Staff Summary Report

SUBJECT: Hold a public hearing for approval with conditions of a Sidewalk Café Permit for Devries Restaurants LLC, dba Marvos "Taste with a Twist" (70786), 699 S. Mill Ave, Dale Donald Devries, Applicant.

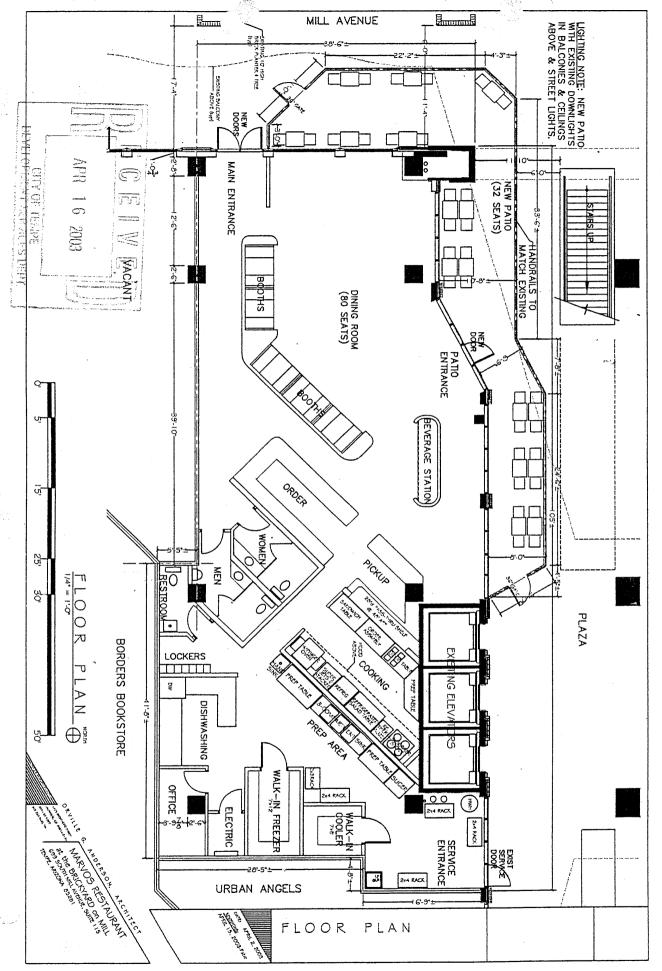
- 1. Table height against outside railing must be no higher than 30 inches; tables abutting the establishment are allowed to be up to 42 inches in height; chairs are required
- 2. No speakers shall be allowed into the extended service area
- 3. No cans or glass bottles are allowed into the extended service area at any time, including special events (which is defined as a City permitted event approved by the Special Events Committee) occurring adjacent to the service area
- 4. Stemware/glassware are only prohibited during special events.
- 5. Railings/gates for the extended service area shall be a minimum of 42 inches and designed with an angular or circular feature on the top of the railing
- 6. Establishment must comply with all State and City laws

- 1. No parking variance is required.
- 2. Outdoor patio shall not encroach into required six (6) foot clear sidewalk pedestrian thoroughfare.
- 3. Obtain Design Review approval and required sign permit for any exterior menu board signage.
- 4. A minimum three (3) foot wide clear pedestrian path is required from the gate entrance to the building entrance.
- 5. Patio gate clearances & requirements shall comply with ADA Chapter 4.13. Latch-side clearance of the patio gate requires the width of the door/gate plus 12". Pull-side clearance requires width of door/gate plus 18".
- 6. Patio gates shall provide a minimum clear opening width of 32" with the gate(s) open 90 degrees.

7. Gates shall swing in the direction of exit travel.

8. Gates shall have no latching/lock device unless it is panic hardware.

9. All new patio fence and gates shall be painted to match existing fence/gate colors on property. If there are none, Design Review staff shall approve color prior to installation.
